INTRODUCTION

San Diego Gas & Electric Company (SDG&E) filed a Proponent’s Environmental Assessment (PEA) as part of its application for a Certificate of Public Convenience and Necessity (CPCN) for the Sycamore to Penasquitos 230kV Transmission Line Project (Proposed Project) to the California Public Utilities Commission (CPUC) in April, 2014. Subsequent to filing the PEA and publication of the Draft Environmental Impact Report (EIR) by the CPUC, minor project engineering and design refinements (Minor Design Refinements) were made to SDG&E’s Proposed Project. Additionally, SDG&E has performed a preliminary review of the alternatives analyzed in the DEIR and has included suggested refinements to those alternatives primarily for feasibility reasons. These changes were the result of ongoing engineering, updated construction planning/sequencing, and new design specifications.

Sycamore to Peñasquitos 230kV Transmission Line Project

Exhibit 1 - Updated Proposed Project Route Map

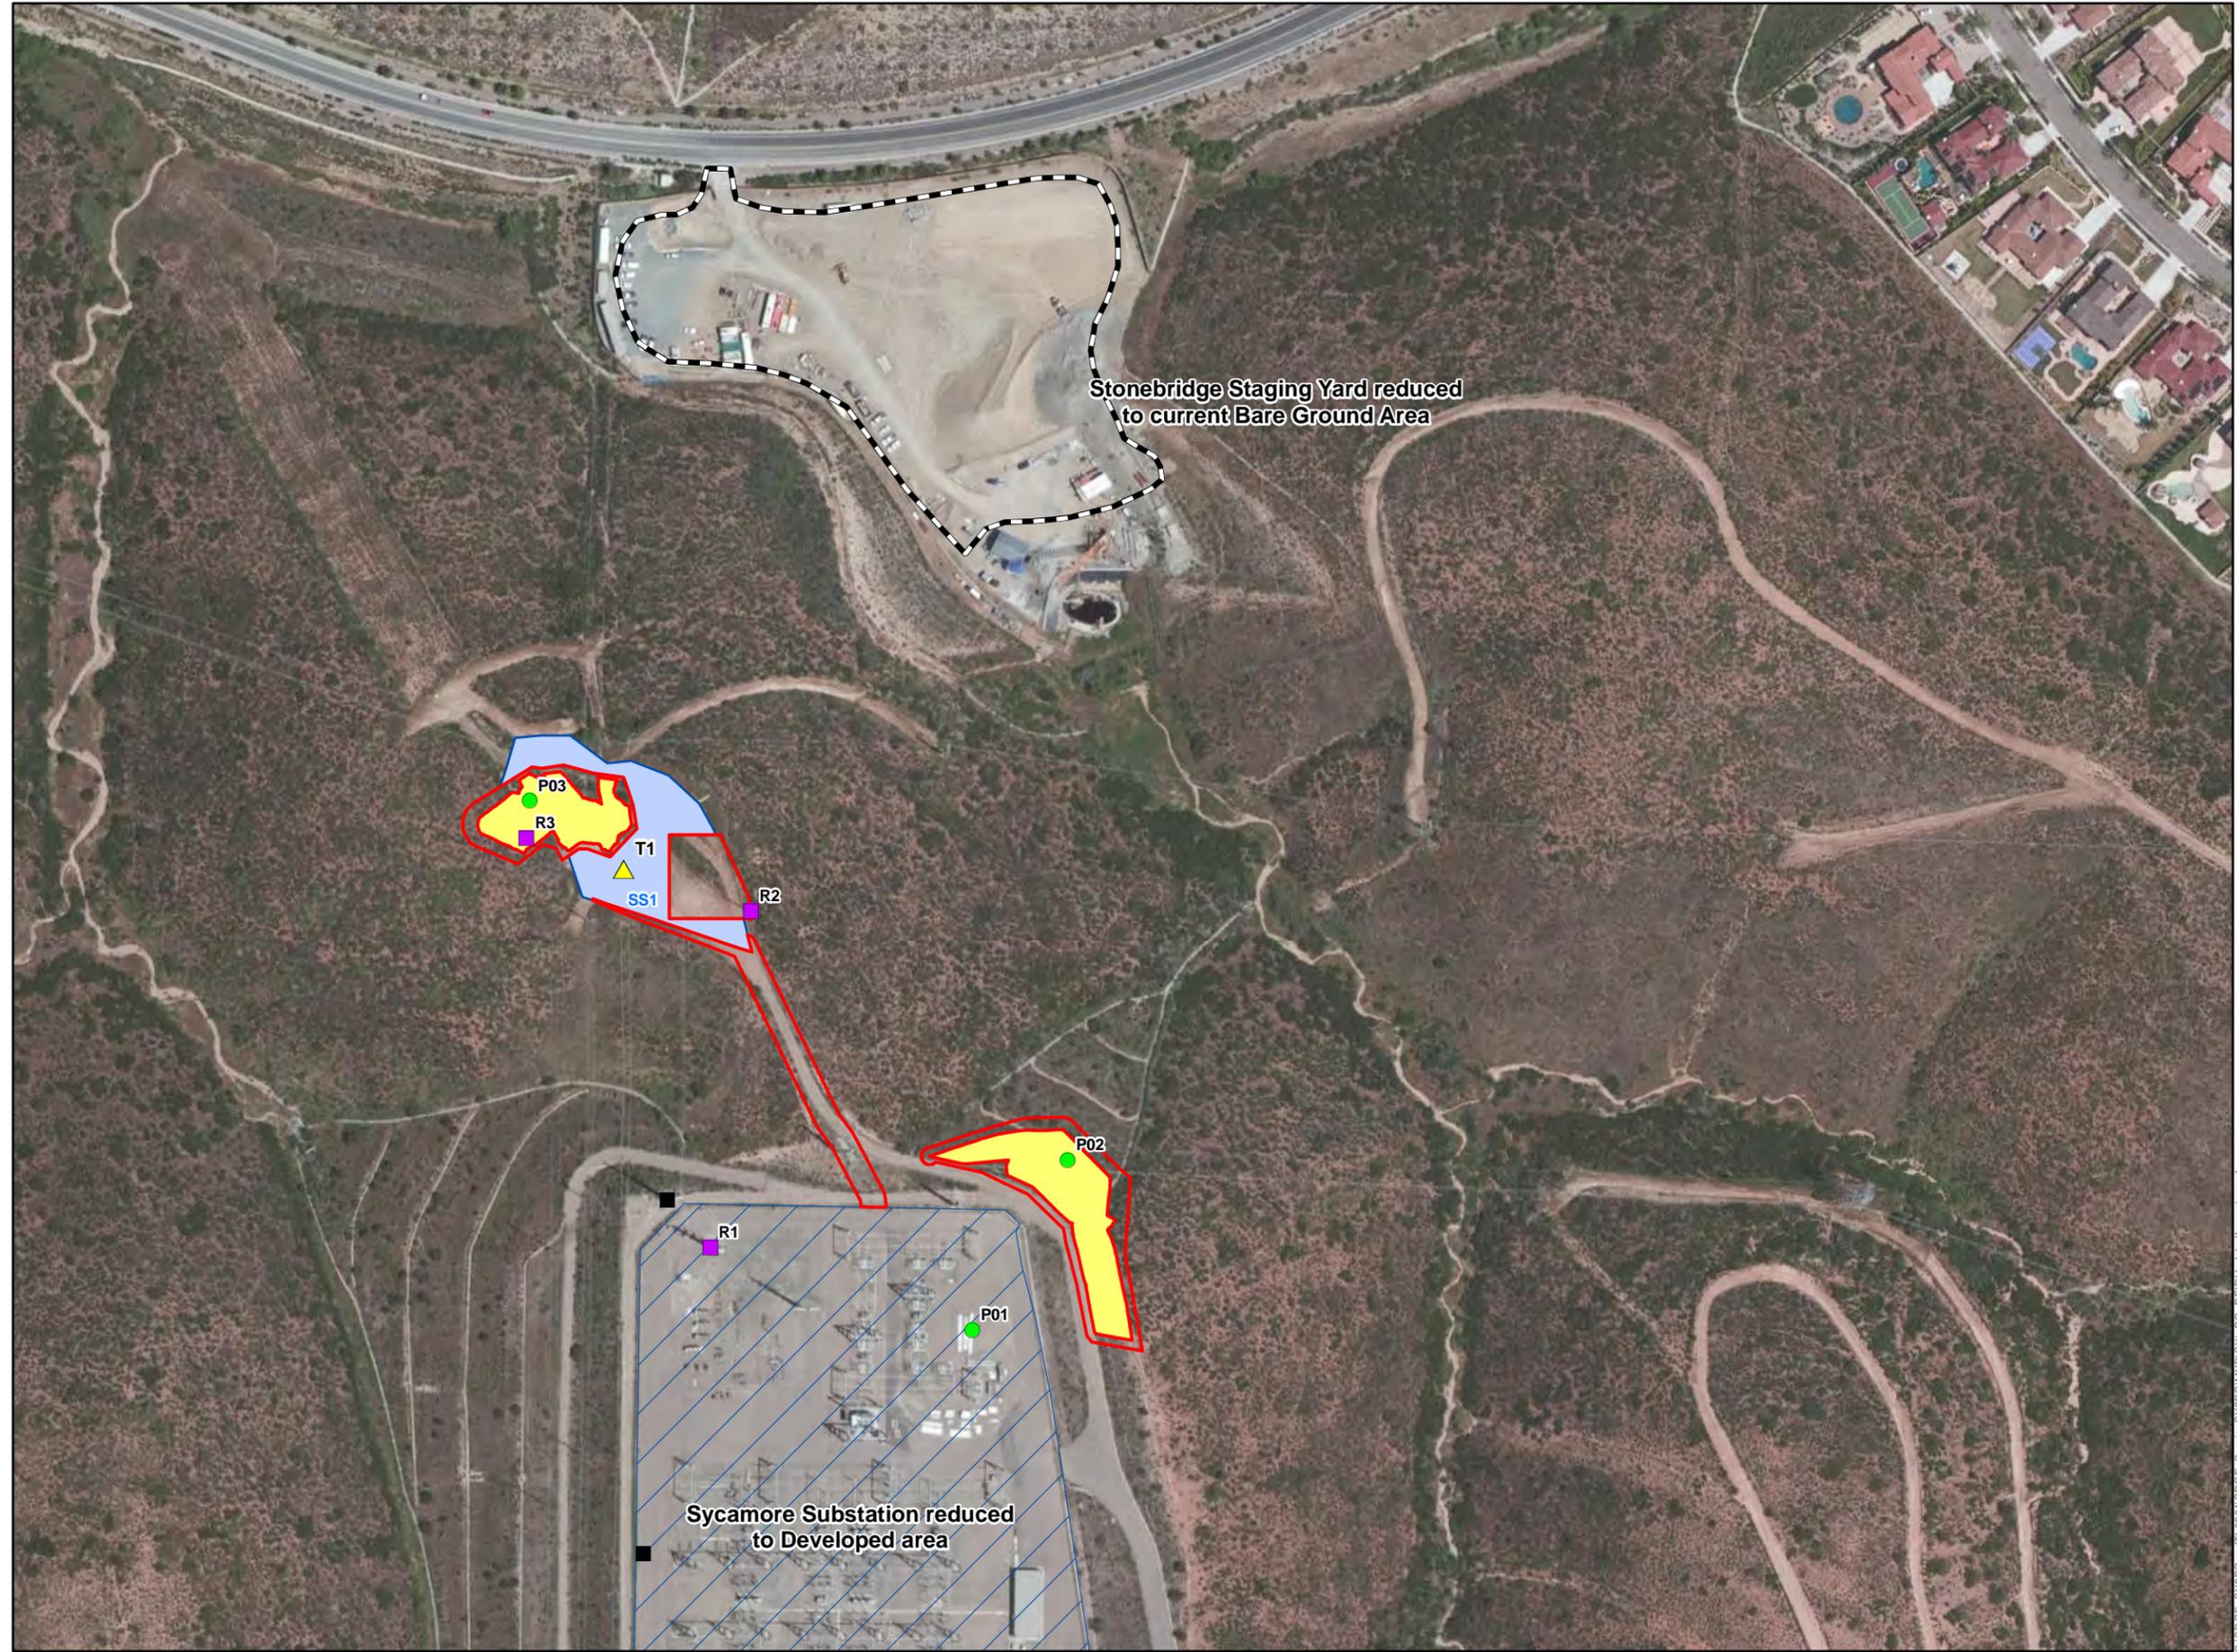
Stowe Staging Yard reduced
to Disturbed area

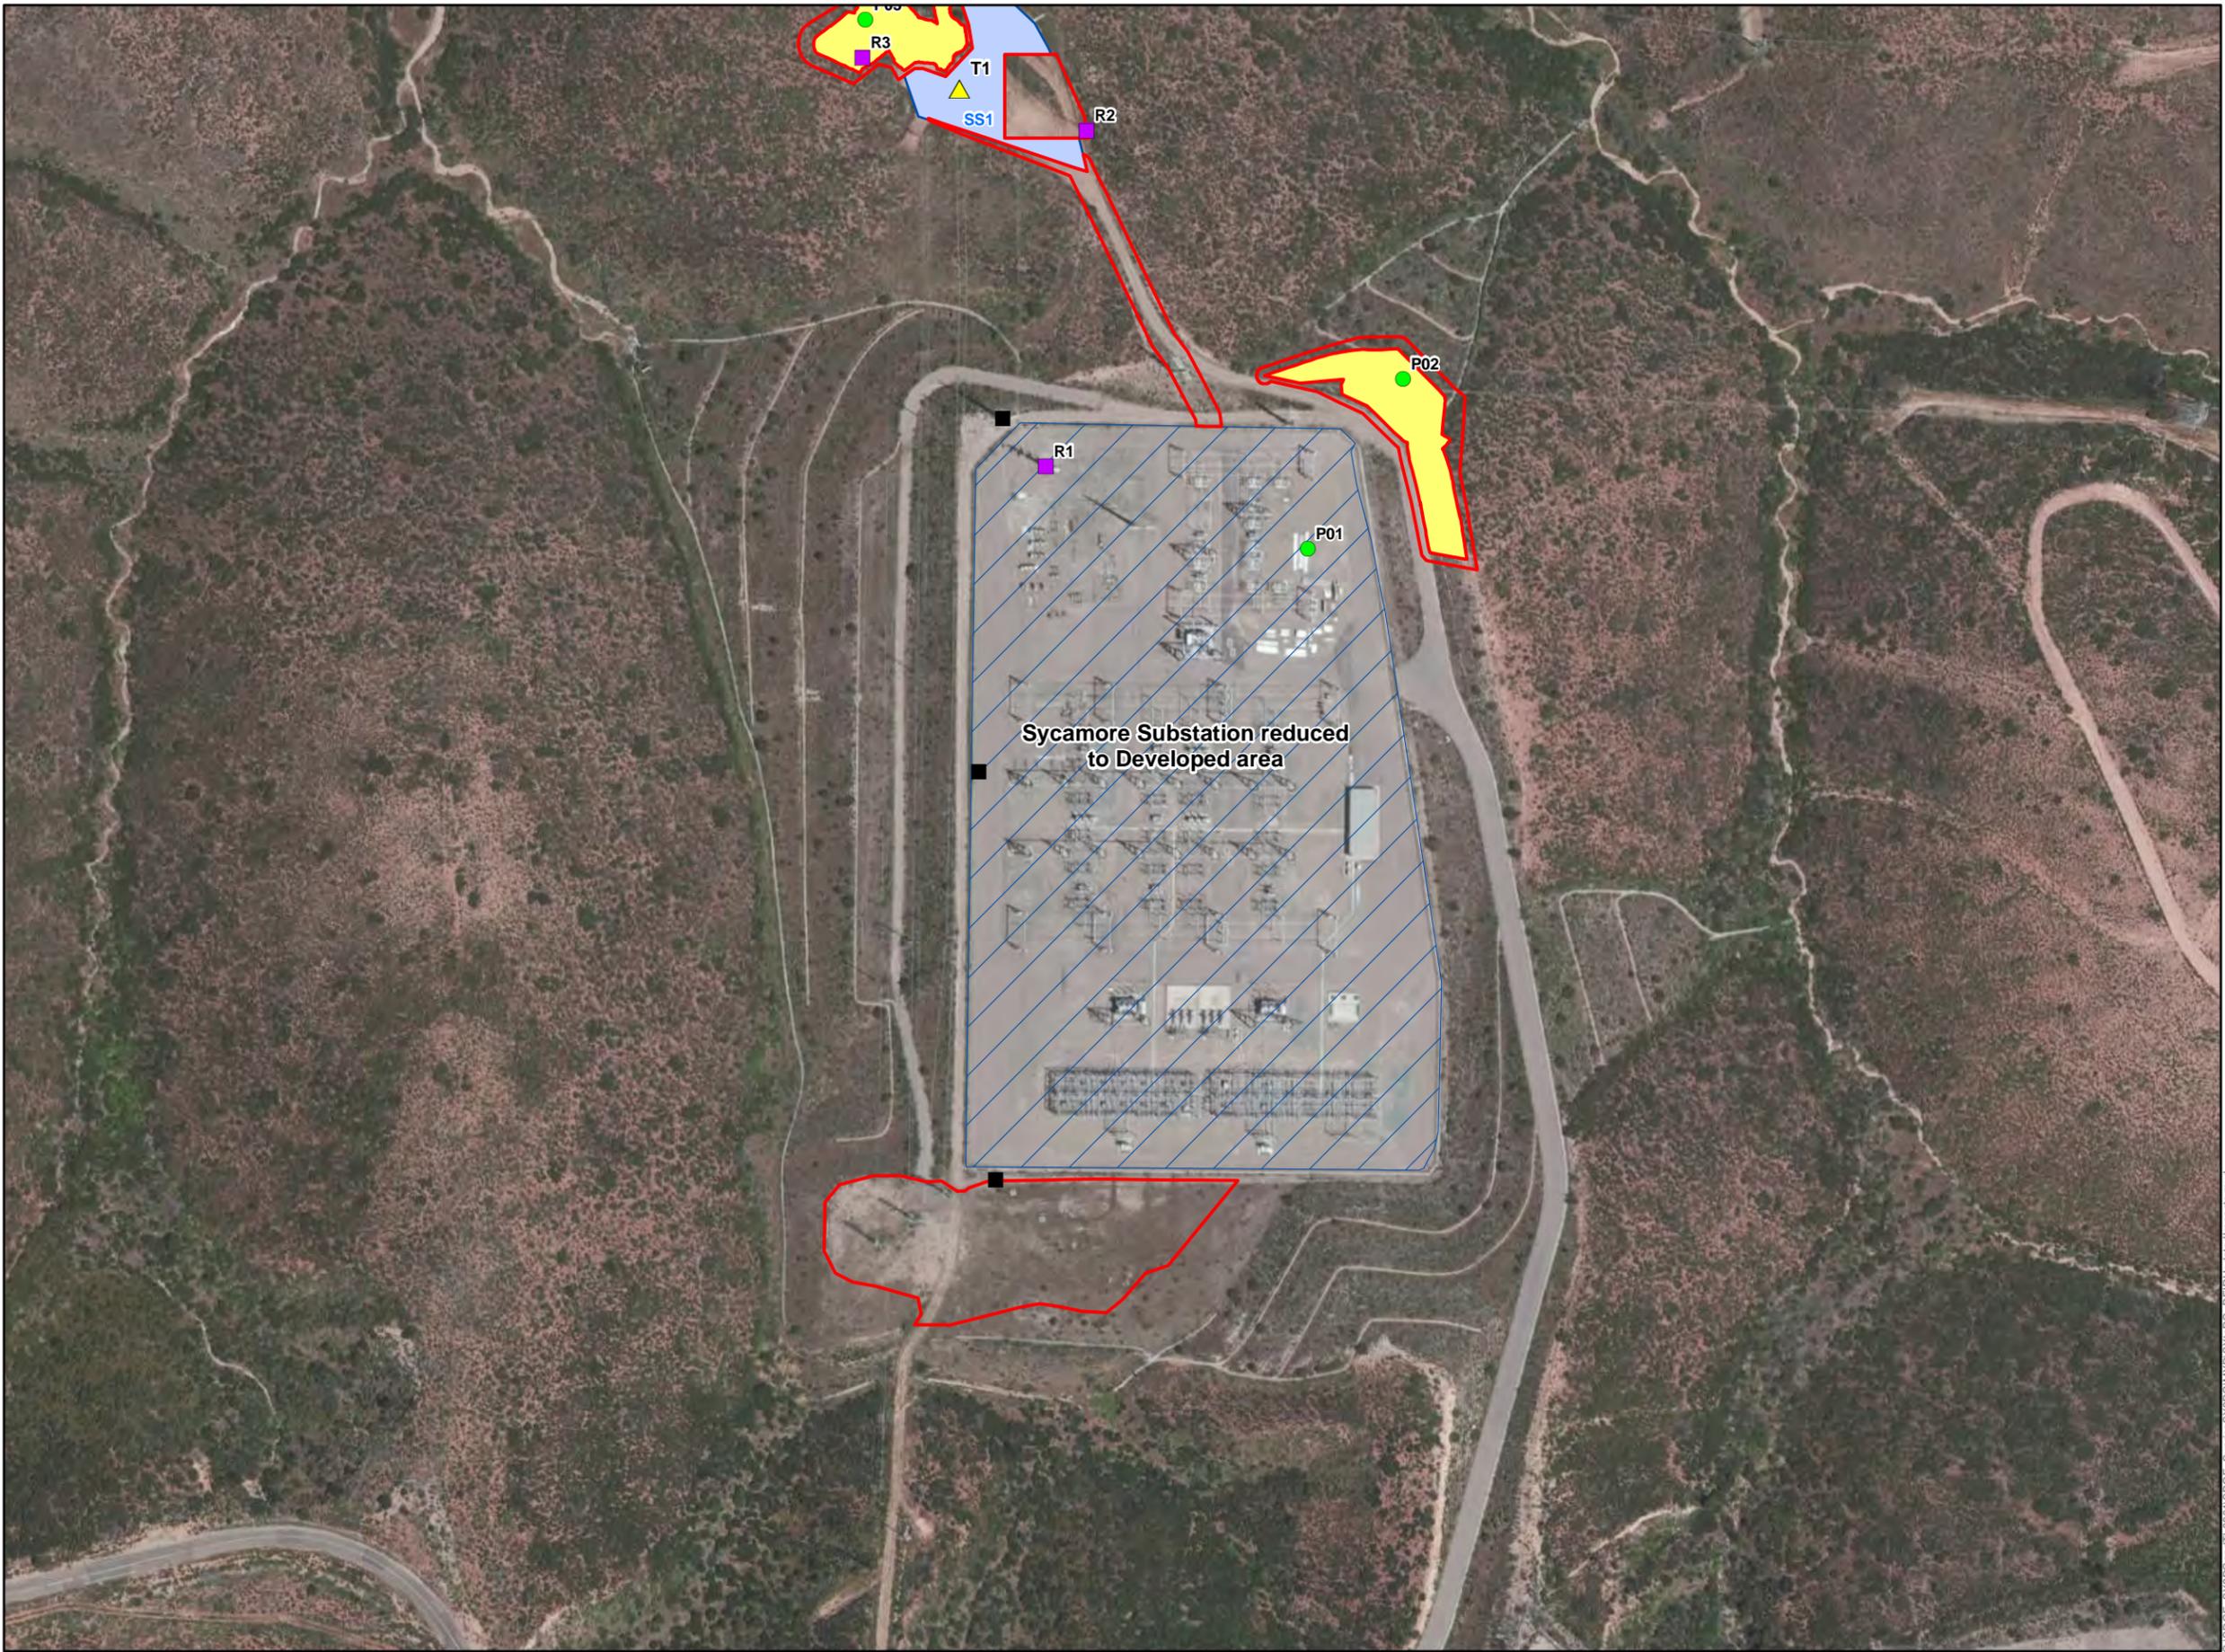
Stonebridge Staging Yard reduced
to current Bare Ground Area

Exhibit 10 - Detailed
Comment on DEIR Alternative 1

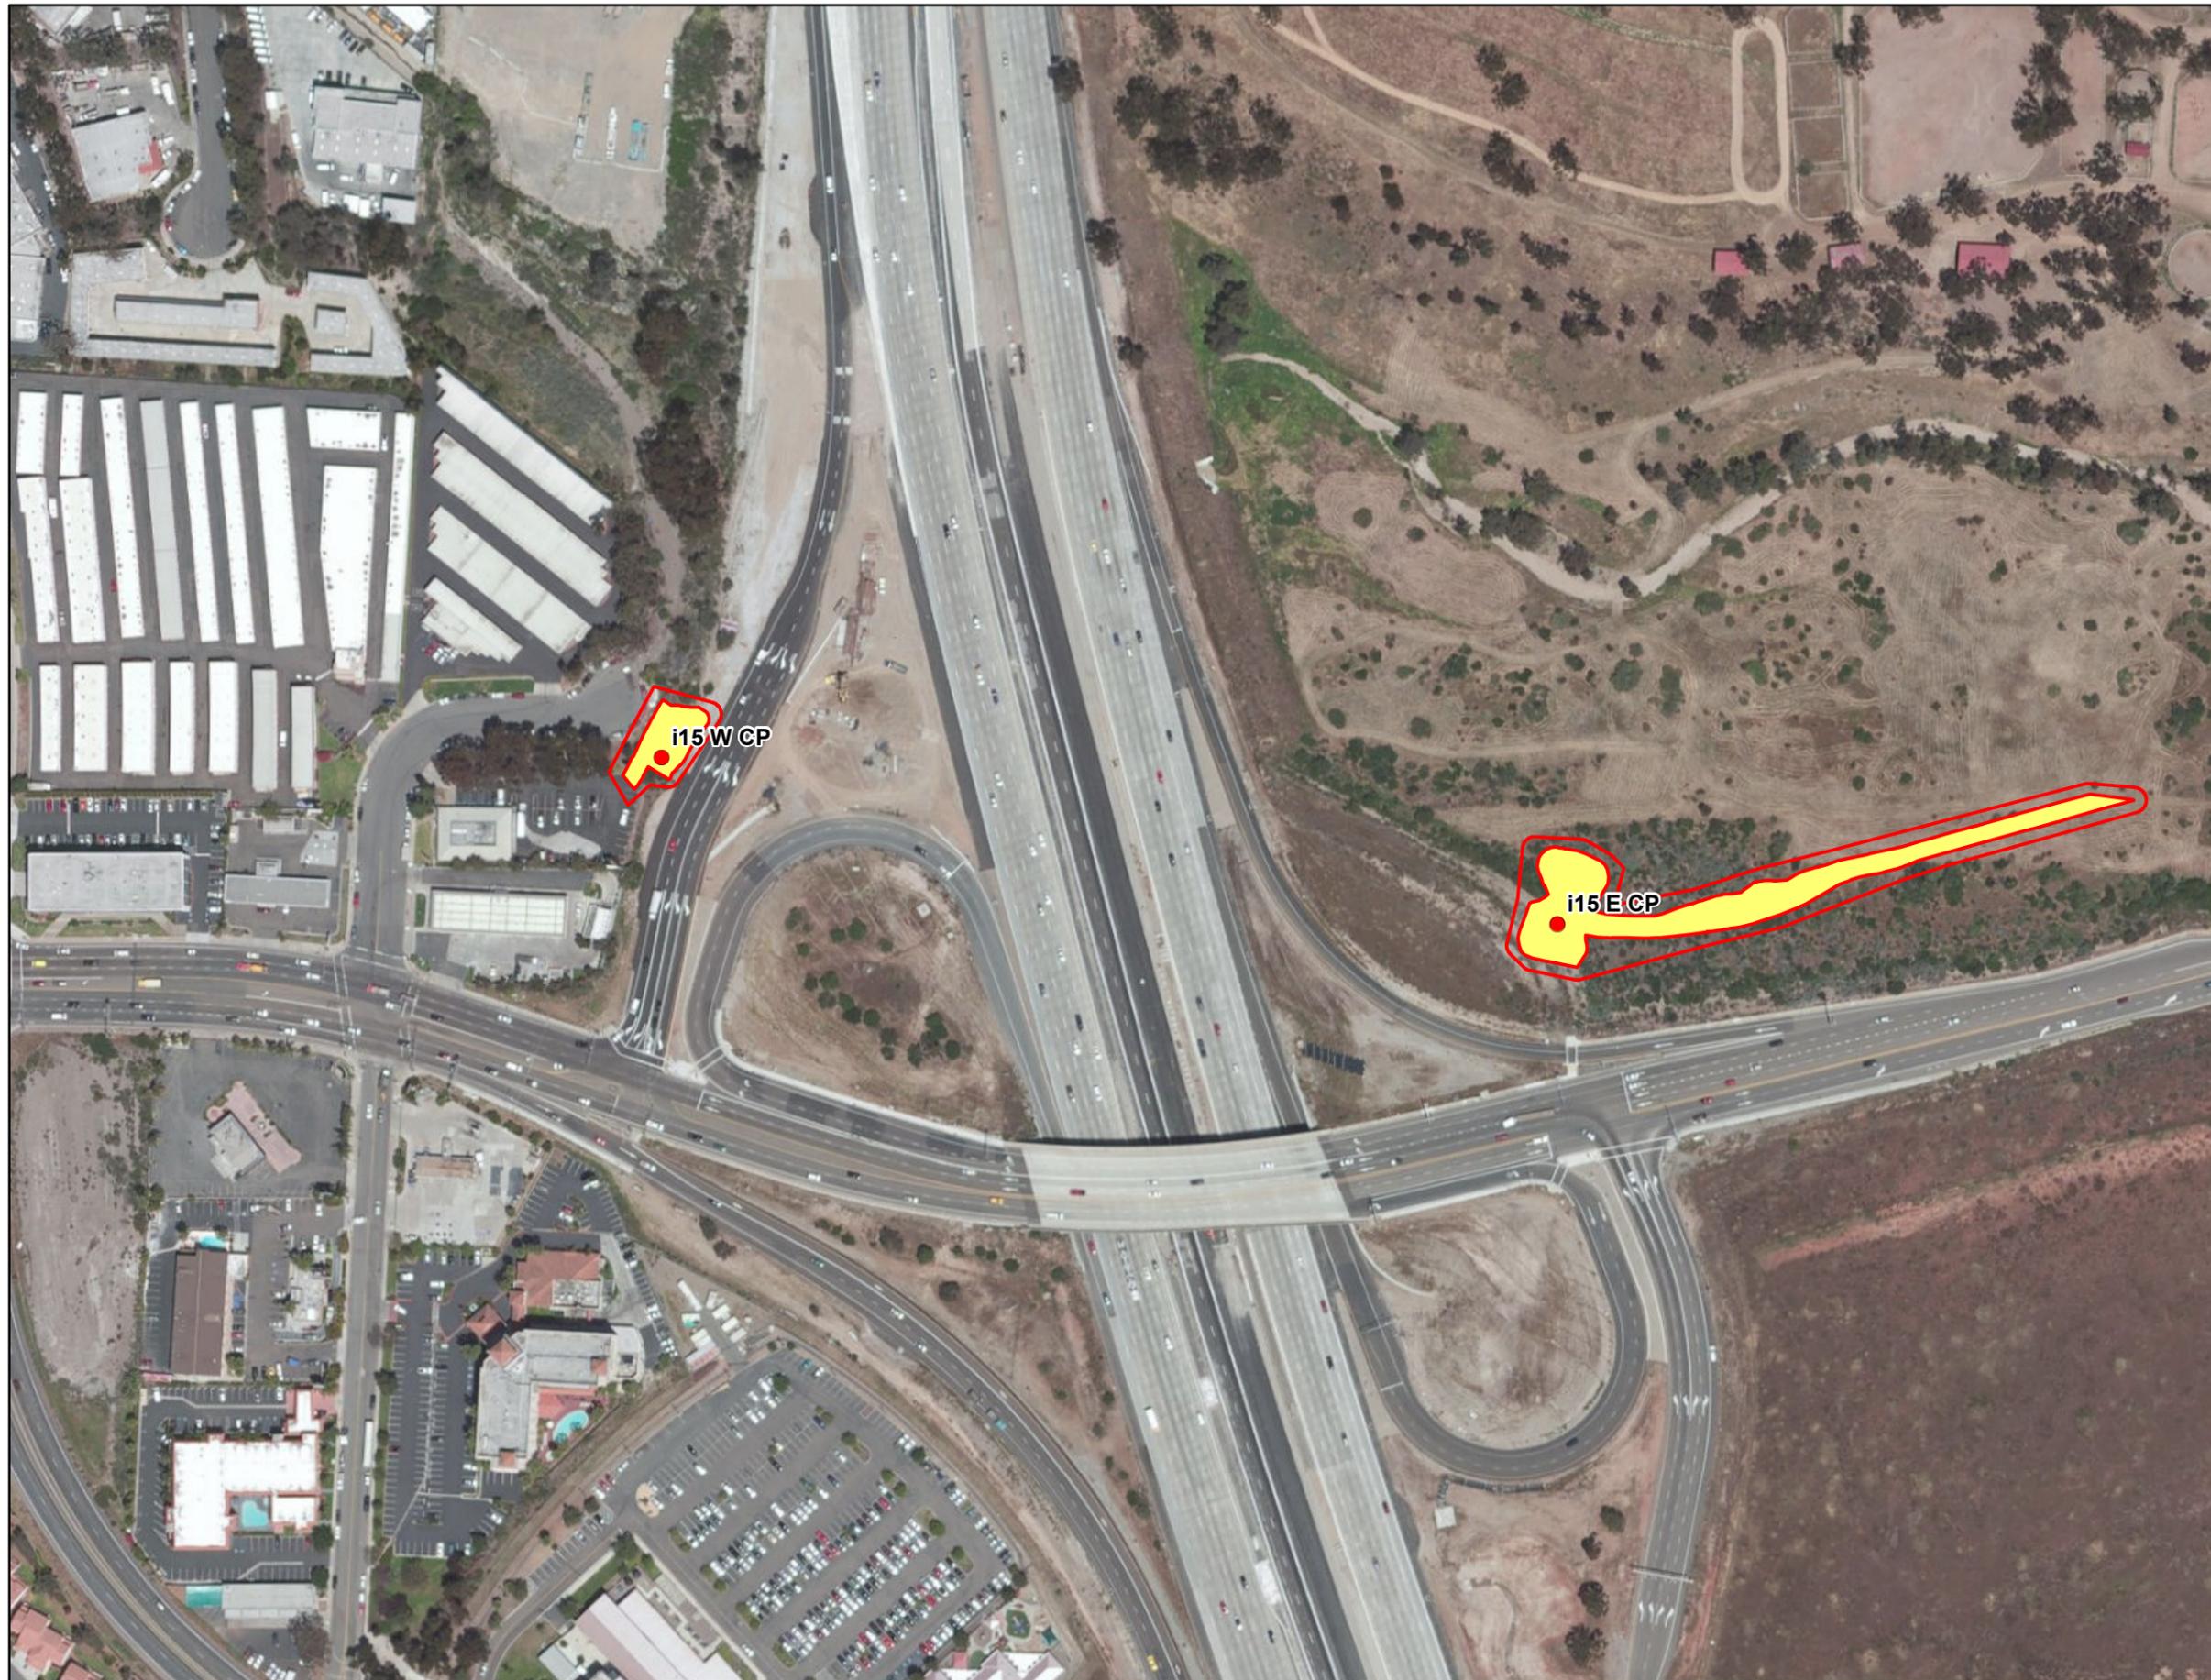
- As referenced in the Comment No. 12, Exhibit 10 contains a figure depicting SDG&E comments on DEIR Alternative 1 (cable pole south of Carmel Valley Road).
- As referenced in Comment No. 15, Exhibit 11 includes a figure of potential properties for staging yards along the Alternative 5 alignment.
- As referenced in Comment Nos. 236, 237, and 238, Exhibit 12 contains the Completed Geotechnical Study prepared for the Proposed Project.
